## **DETAILED ACTION**

Art Unit: 1794

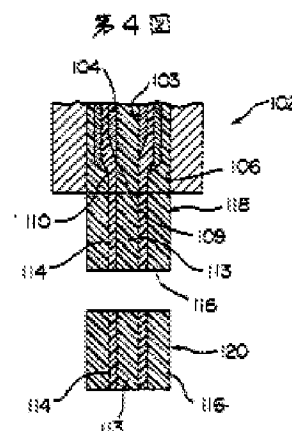
original object (abstract and constitution as provided by Applicant's). Kawaguchi shows an embodiment in Figure 4 in which the inside resin layer, 114, has a varied distance from the axis of symmetry, and the inner resin layer is surrounded by the outer resin layer, 116. Kawaguchi et al. are silent regarding the concentration of the various layers, however it has been shown that absent a showing of criticality with respect to "resin concentrations" (a result effective variable), it would have been obvious to a person of ordinary skill in the art at the time of the invention to adjust the "resin concentrations" through routine experimentation to values, including those presently claimed in order to achieve "firm stable dose and multilayer container". It has been held that discovering an optimum value of a result effective variable involves only routine skill in the art. In re Boesch, 617 F.2d 272, 205 USPQ 215 (CCPA 1980). Figure 5 shows an article wherein the article has an imprisoned inner layer which has variable distances from the axis of symmetry. It is also obvious to vary the concentrations of the resins given that the first resin provides structure to the dose and the functional layers provide properties, i.e. gas barrier

14. In regards to claim 4, figure 4 shows an embodiment wherein there are two different inner layers.
